**No. SunPetro/NGC with AGT Facility/2023-24/SPPL-166/Bulletin-3**

## BULLETIN #3

**Sub: Natural Gas Compression with Associated Gas Treatment Facility in Bhaskar-I field in Gujarat.**

**Ref: Tender No.: SunPetro/NGC with AGT Facility/2023-24/SPPL-166**

**Proposed  
Compression  
facility location**

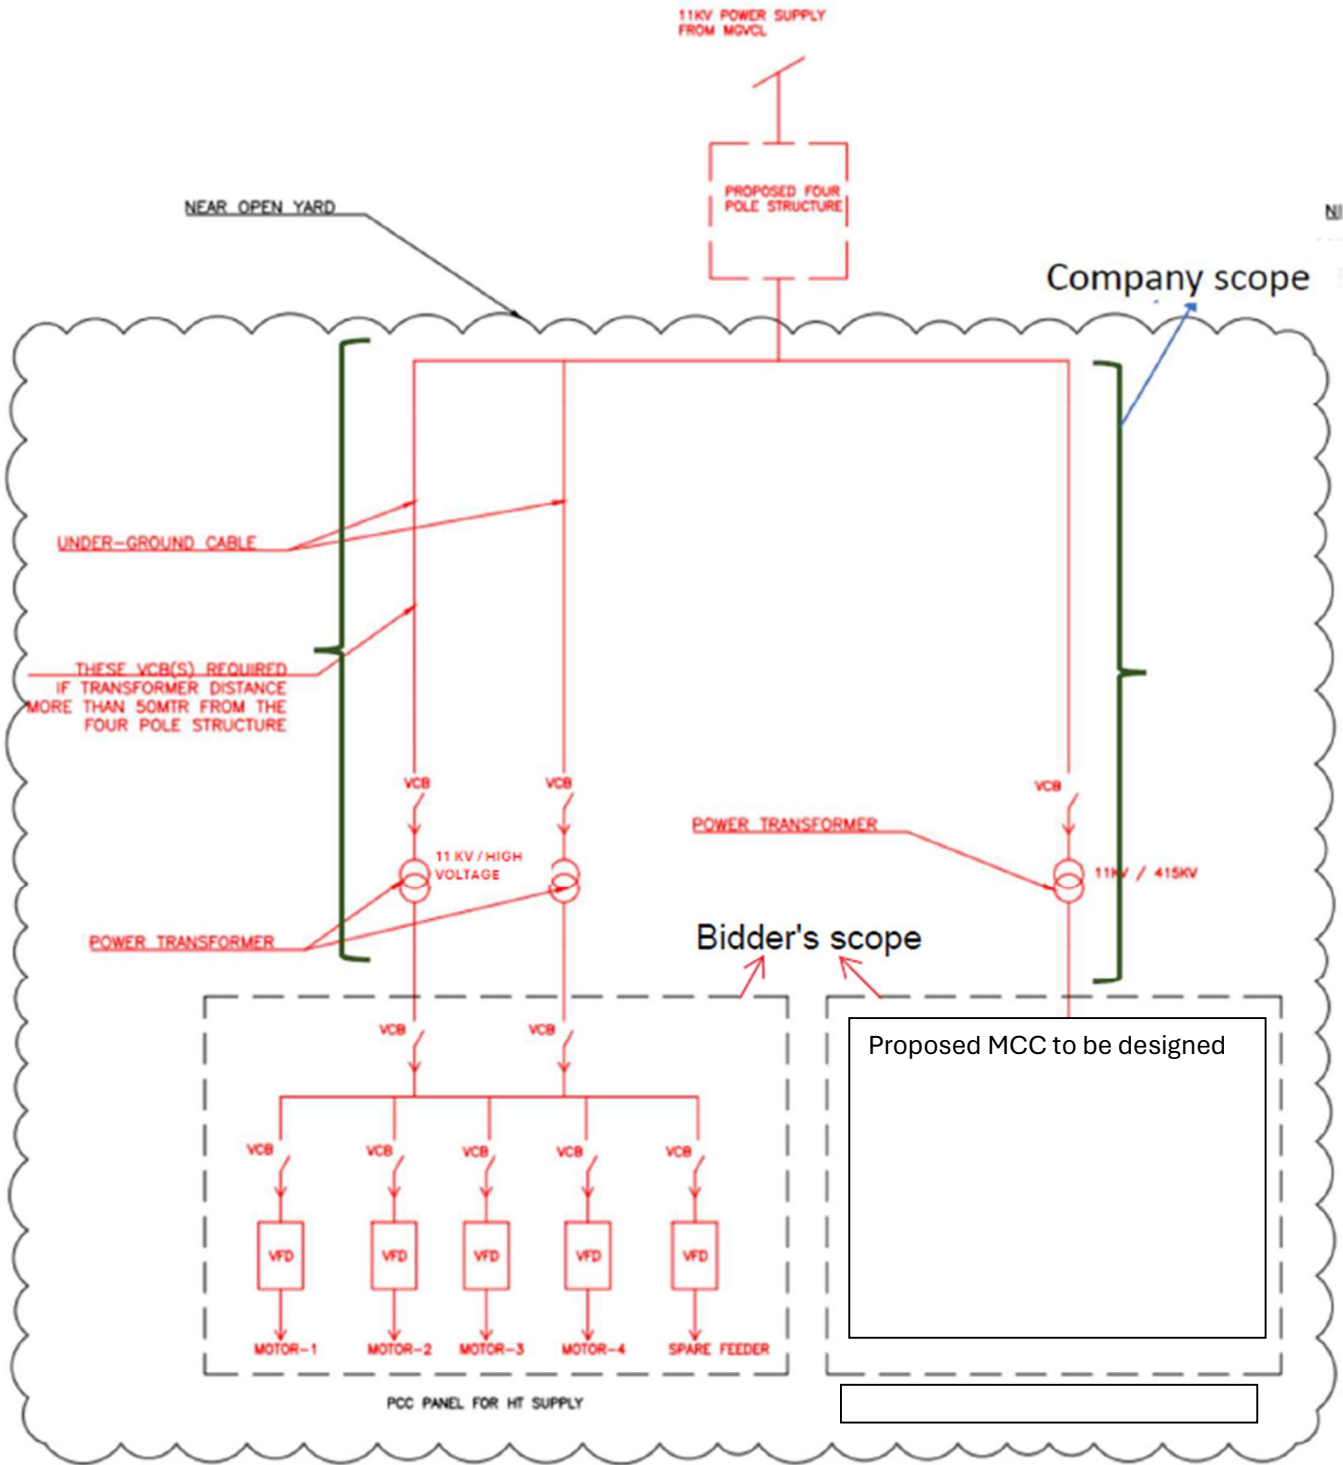
14	SunPetro/NGC with AGT Facility/2023-24/SPPL-166	45 of 84	Drawing	Plot plan with proposed location	During the site visit, it was observed that proposed location is very near to boundary wall and not as per DGMS/OISD requirements. Please provide new location. Please also provide AUTOCAD copy of Plot plan.	PI refer attached updated Plot plan, Required space shall be available ~220 x 160 m , However , bidder to develop the plot plan for present & future compressors & associated facilities in most optimised way complying to OISD-118.
15	SunPetro/NGC with AGT Facility/2023-24/SPPL-166	46 of 84	3.1	Tentative Process Flow Diagram placed below-	Please confirm the expected temperature at compressor suction after gas treatment in DPCU.	As per standard design & engineering practices.
16	SunPetro/NGC with AGT Facility/2023-24/SPPL-166	46 of 84	3.1	Tentative Process Flow Diagram placed below- Gas to local consumer after DPCU, considered 25000 m3	We understand that, 25000 m3 is 25000 SCMD.	Understanding is correct.

89	SunPetro/NGC with AGT Facility/2023-24/SPPL-168	-	-	General Query	Please provide soft copies of Existing SLD, Load details, P&IDs, Plot plan.	Proposed SLD and revised Plot plan attached for reference

# Typical architecture for connectivity of new Hybrid system to existing system

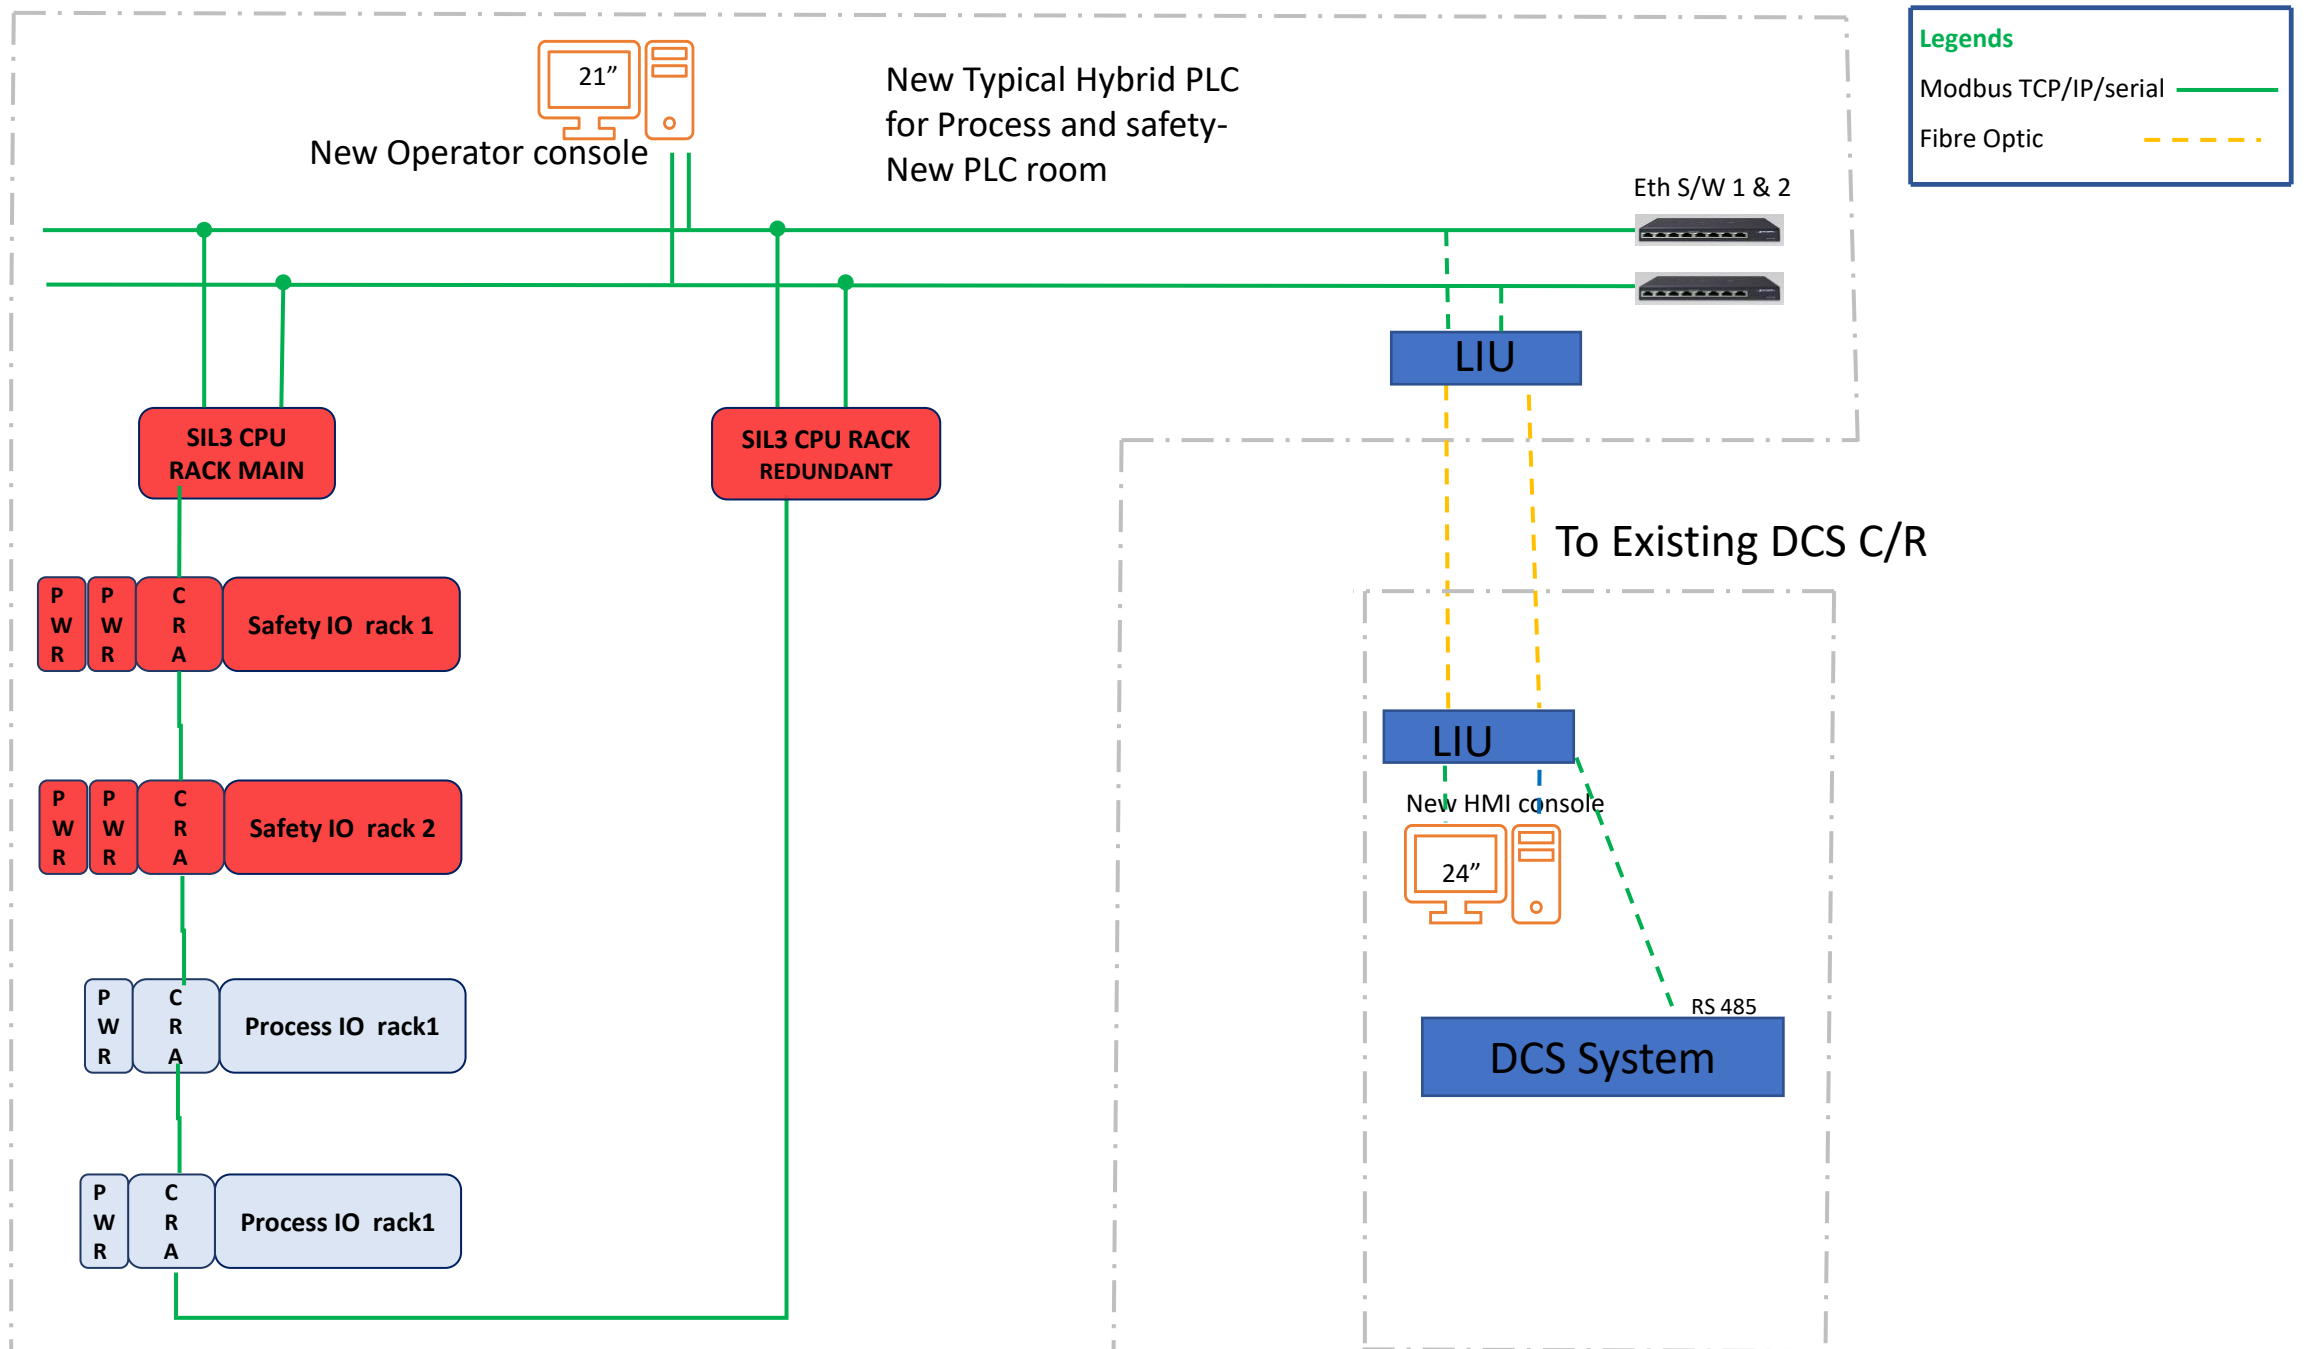
42	SunPetro/NGC with AGT Facility/2023-24/SPPL-166	49 of 84	4.4.	a. The bidder shall be responsible for integration of DCS /ESD and F&G system to our existing DCS system (Installed M/s Emerson system Delta V) in control room approximately 350 away from this proposed facility. Integration of following for control & monitoring at control room.	Kindly specify the make of F&G system.	'DCS controller is MX (Make: DELTA V from M/s Emerson) 1. DCS Controller -1 controller(1+1) hot standby 2. DCS Controller -2 ,controller(1+1) hot standby. 3. 'F&G system: SIS controller SIL3 (1+1) hot standby model is SZ It has 07 nos of sub controller each controller(1+1) hot standby. RS 485 module is available in existing DCS system. Local Operator console to be provided at Field PLC room and HMI shall be provided in existing control room. Note; New hybrid PLC system communication link between new hybrid system and new HMI in DCS room shall be redundant.  An indicative Architecture of PLC is attached for reference. Further the following should also be considered in

scope of supply by the bidder: 1. Additional 20 % I/O Tag licenses for Hybrid PLC system 2. Additional 20 % Zener Isolators each for AI, DO and AO cards 3. Addition 20 % spare I/O Peripherals cards for Hybrid PLC system including mounting plate accessories if any
43	SunPetro/NGC with AGT Facility/2023-24/SPPL-166	49 of 84	4.3	Electrical System	Please confirm Spare/Redundancy philosophy for electrical system.	Refer Sr No 28.
44	SunPetro/NGC with AGT Facility/2023-24/SPPL-166	49 of 84	4.3	Electrical System	Please confirm the requirement of standby transformer.	Refer Sr No 28.
45	SunPetro/NGC with AGT Facility/2023-24/SPPL-166	49 of 84	4.3	Electrical System	Kindly confirm HT Cable laying will be underground or above ground ?	All the cables shall be laid in the trench on GI coated cable tray.
46	SunPetro/NGC with AGT Facility/2023-24/SPPL-166	49 of 84	4.3	Electrical System	Kindly provide Available space for new HT panel, MCC panel, Transformer, VFD in substation room.	Space shall be provided for new Substation near to proposed facility.

- Note: 1. The communication link between New PLC room and existing DCS Control Room shall be full redundant (primary and secondary full duplex)  
 2. The existing DCS system has spare RS 485 card  
 3. All soft I/O Tags of hybrid PLC –New shall be imported to existing Delta V DCS system including creation of Graphics in existing DCS system, new operator console in New PLC room as well as new HMI (to be installed in Existing DCS control room)  
 4. The above proposed Architecture is only indicative. The bidder may propose any other suitable architecture as per good engineering practices.
